Access Compliance Report Public Rights-of-Way (Curb Ramps)

Main Street: WALLINGSFORD_RD Cross Street: BRADBURY_RD Location: NE

ADA ID: RPRK211209135000 Ramp Type: Type 1 - Perpendicular Diagonal Initial Pass/Fail: Pass Overall Compliance: No Severity Score: 0

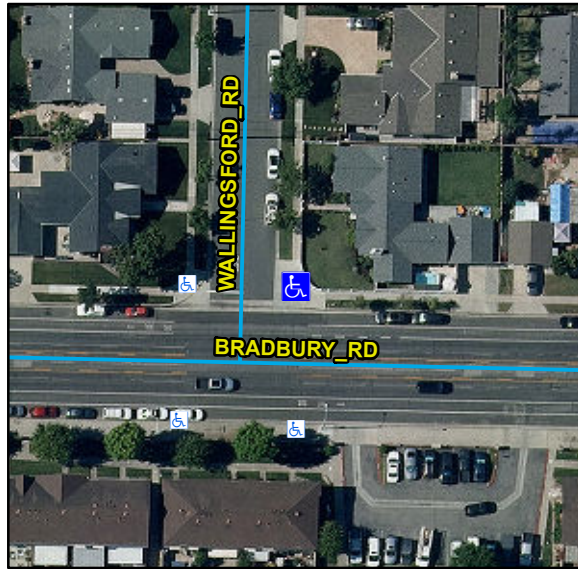
Compliance	Description	Data	Compliance	Description	Data
N/A	Ramp Length (in)	70	N/A	Flare Type LT	
Yes	Ramp Width (in)	48			Sloped
Yes	Ramp Run Slope (%)	5.7	Yes	Flare Slope LT (%)	4.2
Yes	Ramp Cross Slope (%)	1.7	N/A	Flare Traversable LT	Yes
N/A	Landing Present	Yes	N/A	Flare Type RT	
N/A	Landing Length (in)	49			Sloped
Yes	Landing Width (in)	48	Yes	Flare Slope RT (%)	6.8
Yes	Landing Run Slope (%)	0.5	N/A	Flare Traversable RT	Yes
No	Landing Cross Slope (%)	2.6	Yes	DWS Provided	Yes
N/A	Landing Movement Obstructed?	No	Yes	DWS Contrast	Yes
	Landing Movement Type	N/A	Yes	DWS Length (in)	36
N/A	Landing Shared	No	Yes	DWS Full Width	Yes
N/A	Clear Space	Yes	Yes	DWS Offset Left (in)	0
N/A	Clear Space To Crosswalk (in)	48	Yes	DWS Offset Right (in)	N/A
N/A	Marked Crosswalk 1	No	N/A	Marked Crosswalk 2	No
	Crossing 1 Direction	W		Crossing 2 Direction	S
	Marked Crosswalk 1 Width (in)	N/A		Marked Crosswalk 2 Width (in)	N/A

Remove & Replace Landing.

R304.5.3, STD 1115
